Final Evaluation and Environmental Assessment for Expansion of the Existing Humboldt Open Ocean Disposal Site (HOODS) Offshore of Eureka, California

Appendix F

STAFF REPORT: REGULAR CALENDAR

Consistency Determination No.: CD-0001-20

Exhibit 2
 CD-0001-20

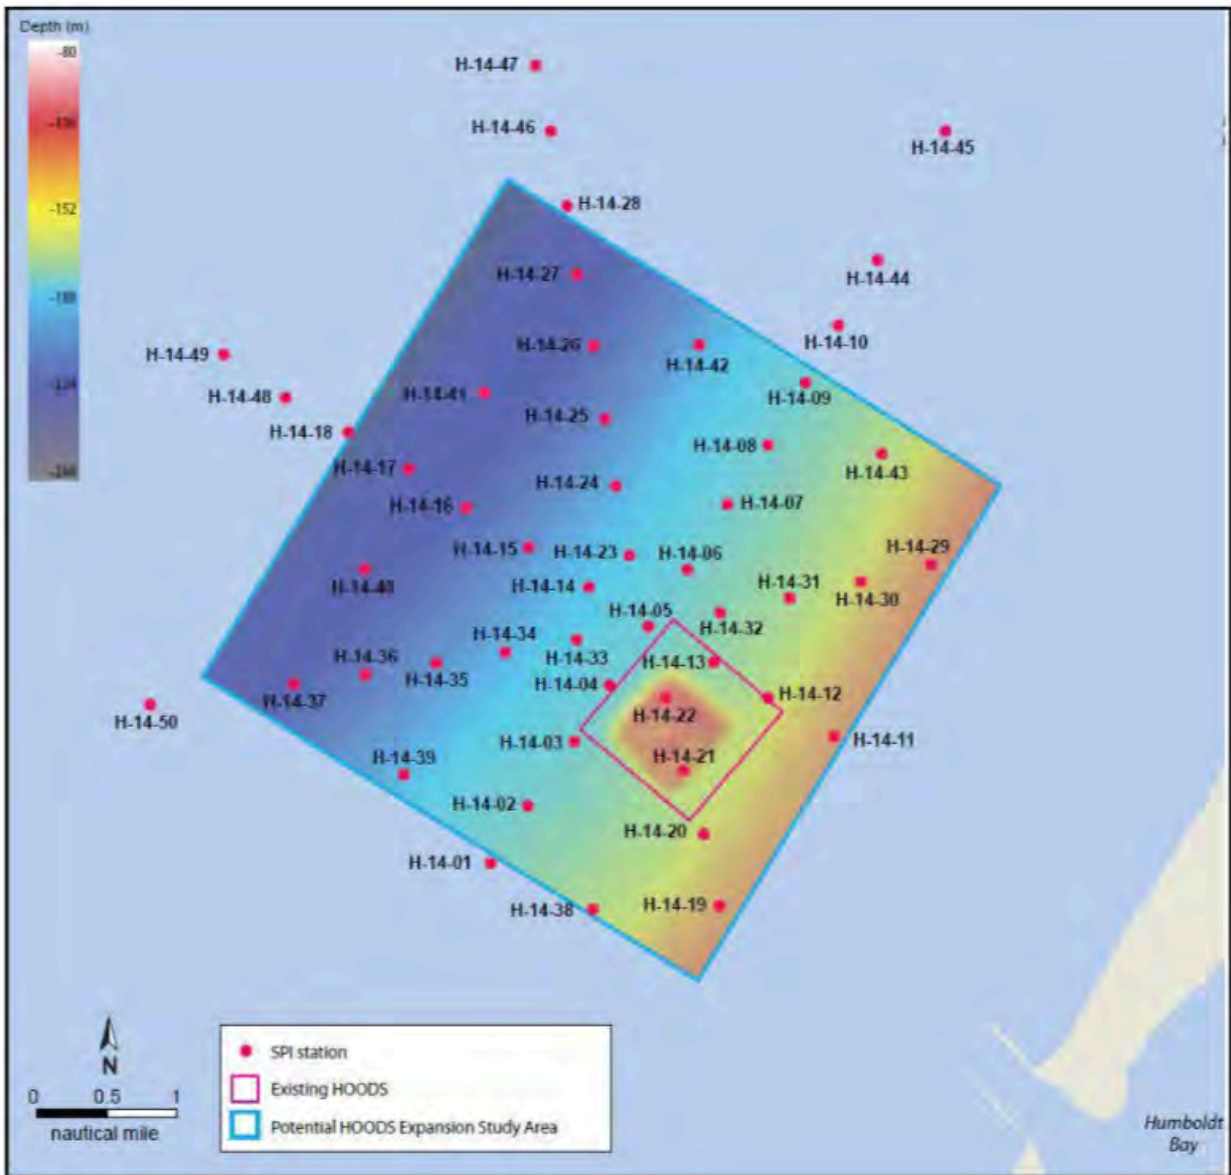
Since 1995, an average of 1 million cubic yards of clean dredged material has been placed at HOODS annually. As a result, and as noted previously, sediment disposal has created mounding and the original site has reached capacity ([Exhibit 2](#)). No additional sediment may be disposed of at HOODS without creating obtrusive mounding. The proposed expansion of HOODS is necessary as there are currently no feasible offshore, nearshore, or upland alternatives for the disposal of dredged sediment from Humboldt Bay channels.

Exhibit 3
CD-0001-20

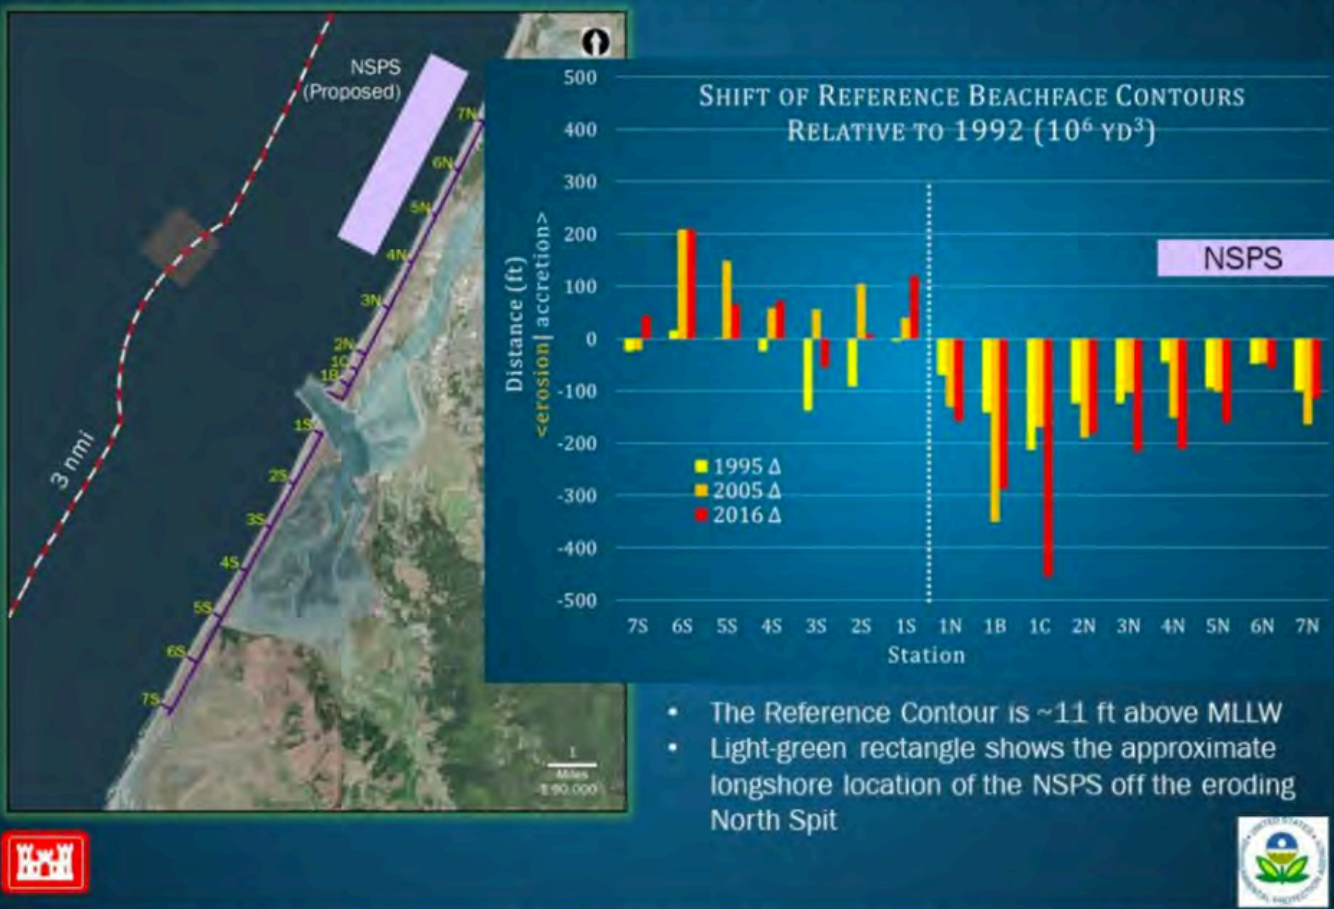
The HSMP uses aerial photography to determine the shoreline position change over time along the North and South Spits adjacent to the entrance channel. [Exhibit 3](#) depicts some of the results from this monitoring, clearly indicating that the North Spit has been eroding over the last several decades while the South Spit has more or less been accreting sediment. The magnitude and rate of erosion however is highly dependent on the relative baseline used in the calculations. Prior to 2016, the Corps used the shoreline position from 1974-1990 as the baseline for determining whether “excessive erosion” had occurred. However, it was later determined that the 1974-1990 period could not adequately represent baseline shoreline conditions due to the extensive jetty modifications during that time period. As such, the Corps and the Commission revisited the “excessive erosion” criteria during the review of CD-0005-18 (for the Corps’ 2019 maintenance dredging of the Humboldt Bay federal channels) and established that the baseline should instead be based upon the 1948-1974 timeframe in order to adequately capture the effects of potential erosion due to offshore disposal at HOODS.

The Corps will update the shoreline monitoring report using the new 1948-1974 baseline after it undertakes the next round of aerial photos, expected to occur before 2023. Absent the results of these new erosion calculations, erosion resulting from disposal offshore at HOODS cannot yet be definitively determined. The Commission looks forward to working with the Corps and the EPA to interpret the upcoming shoreline monitoring report and to advance the development of a pilot nearshore placement project should excessive shoreline retreat on the North Spit be confirmed.
